WATTS BAR NUCLEAR PLANT (WBN) - RTD BYPASS LOOP ELIMINATION/UTILIZATION OF
EAGLE 21 ELECTRONICS - FSAR CHAPTER 15

Enclosed are marked-up pages to the WBN FSAR Chapter 15 reflecting the elimination of the RTD bypass loop and the utilization of Eagle 21 system electronics. According to the schedule, it is requested that NRC review these proposed changes and forward questions to TVA the week of February 23, 1987. The enclosed changes, along with any other changes resulting from your review, will be incorporated into a subsequent FSAR amendment.

Figure 15.2-22 Loss of Load Accident with Pressurizer Spray and Power-Operated Relief Valves, End-of-Life

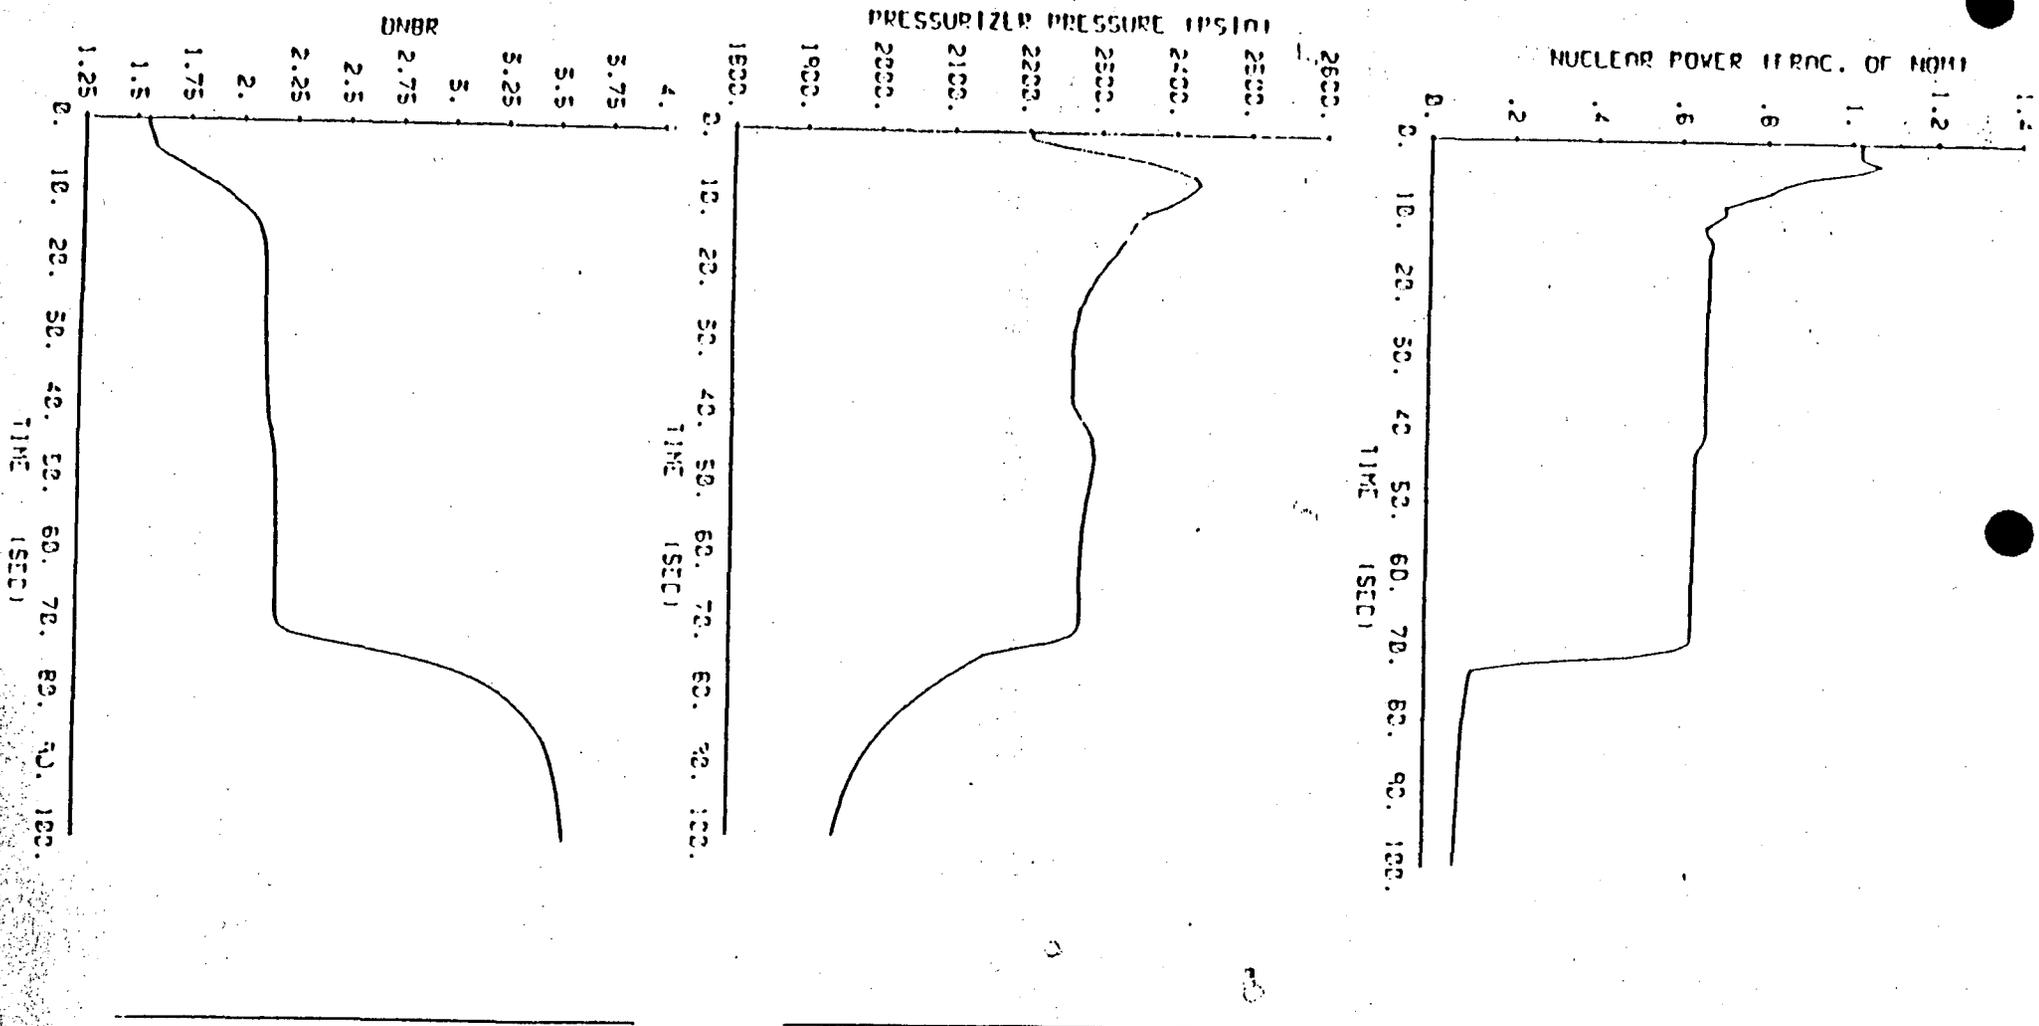
Figures 15.2-21 and 15.2-22 show the responses for the total loss of load at end-of-life assuming a large (absolute value) negative moderator temperature coefficient. All other plant parameters are the same as the above. The DNBR increases throughout the transient and never drops below its initial value. *The reactor is tripped by the low-low steam generator water level signal.*

Figure 15.2-37 Power Transient for Accidental Depressurization of the RCS

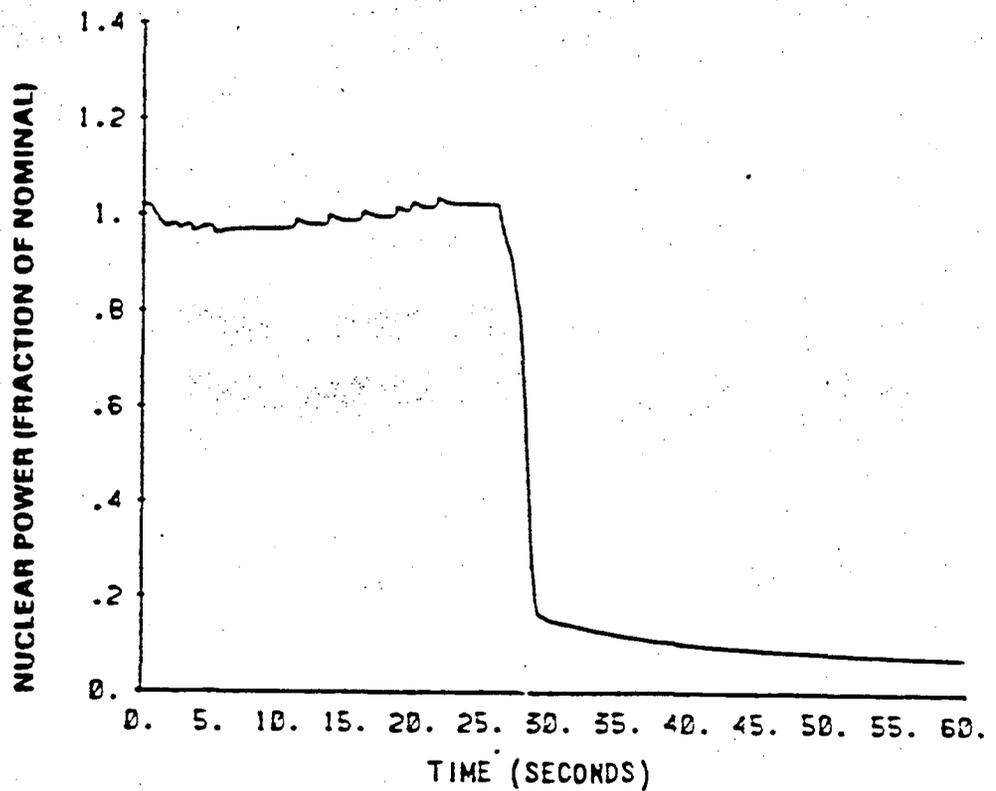
Figure 15.2-37 illustrates the nuclear power transient following the accident. Reactor trip on overtemperature ΔT occurs as shown in Figure 15.2-37. The pressure ~~decay transient~~ following the accident is given in Figure 15.2-38. The resulting DNBR never goes below 1.30 as shown in Figure 15.2-39. The calculated sequence of events for this accident is listed in Table 15.2-1.
